Access Compliance Report

Public Rights-of-Way

Intersection ID: 28390	Main Street: ARDREY_KELL_RD	Cross Street: BRIDGEHAMPTON_CLUB_DR	Location: SW
ADA ID: E2664F93E6EB	Ramp Type: Perp	Initial Pass/Fail: Fail	Overall Compliance: No
		Severity Score: 12.5

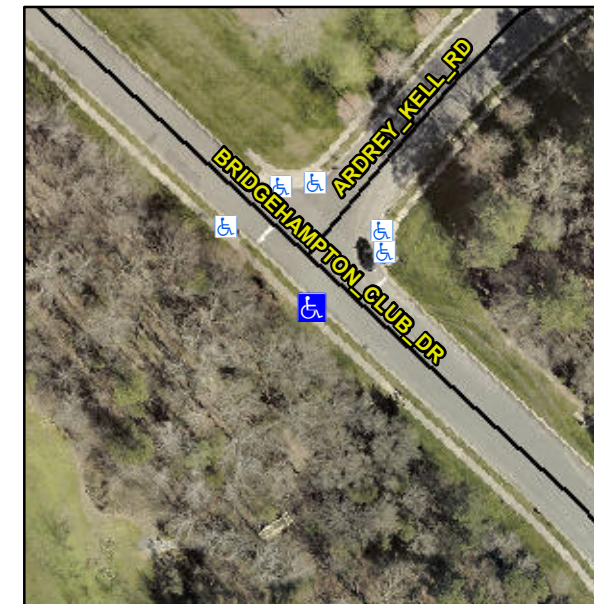
Not Found, R304.2.2

Compliance	Description	Data	Compliance	Description	Data
N/A	Ramp Length (in)	46.0	No	Ramp Slope (%)	8.6
Yes	Ramp Width (in)	133.5	Yes	Ramp XSlope (%)	0.8
N/A	Flare Type LT	N/A	N/A	Flare Type RT	N/A
N/A	Flare Slope LT (%)	N/A	N/A	Flare Slope RT (%)	N/A
N/A	Flare Traversable LT?	N/A	N/A	Flare Traversable RT?	N/A
N/A	Landing Length (in)	N/A	N/A	DWS Provided?	N/A
N/A	Landing Width (in)	N/A	N/A	DWS Contrast?	N/A
N/A	Landing Slope (%)	N/A	N/A	DWS Length (in)	N/A
N/A	Landing X Slope (%)	N/A	N/A	DWS Full Width?	N/A
N/A	Landing Curb? (Y/N)	N/A	N/A	DWS Offset (in)	N/A
N/A	Shared Landing?	N/A			
N/A	Gutter Ponding?	N/A	N/A	Gutter Slope (%)	N/A
N/A	Gutter Lip Ht (in)	3.0	N/A	Gutter X Slope (%)	N/A
N/A	Painted X Walk1?	No	N/A	Painted X Walk2?	N/A
	X Walk 1 Direction	To NE		X Walk 2 Direction	N/A
N/A	X Walk 1 Width (in)	N/A	N/A	X Walk 2 Width (in)	N/A
	X Walk 1 Slope (%)	1.9		X Walk 2 Slope (%)	N/A
	X Walk 1 X Slope (%)	2.7		X Walk 2 X Slope (%)	N/A

Remove & Replace Entire Ramp.
